Inter-Office Communication

Subject: 175

Higher Collector Volts for 575

SUBJECT: Patent Disclosure Letter
Single Cycle and Multiple Cycle Firing
Circuits for Silicon Controlled Rectifiers

FIG. 1 SINGLE CYCLE FIRING CIRCUIT

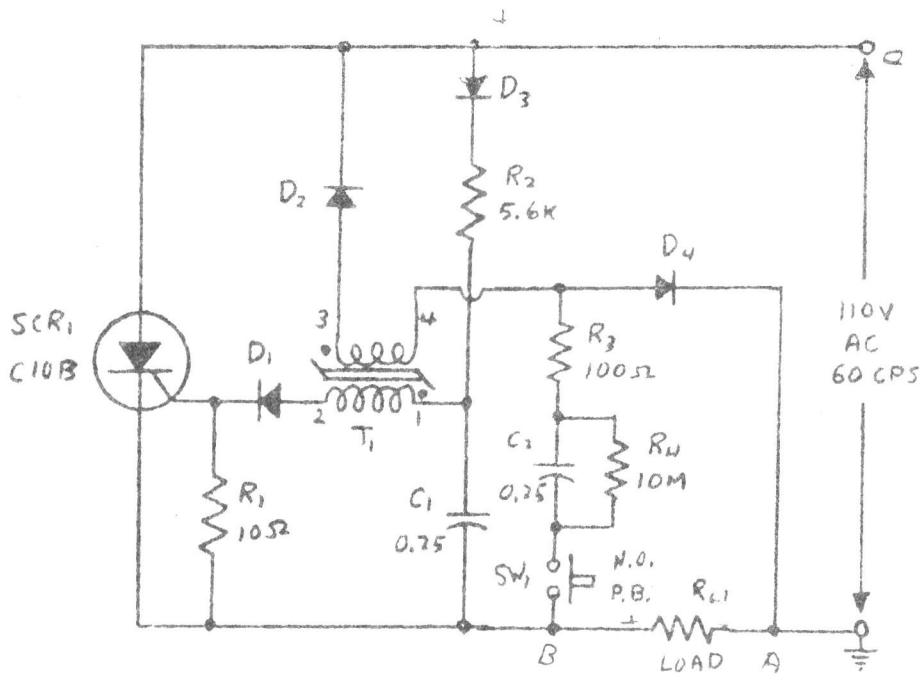
Mr. Pete Sylvan, who is pretty well known to Norm and John Kobbe, presents us with the enclosed Patent Disclosure Letter concerning Single Cycle and Multiple Cycle Firing Circuits for Silicon Controlled Rectifiers. Pete feels it may be something which we would like to build into the 175.
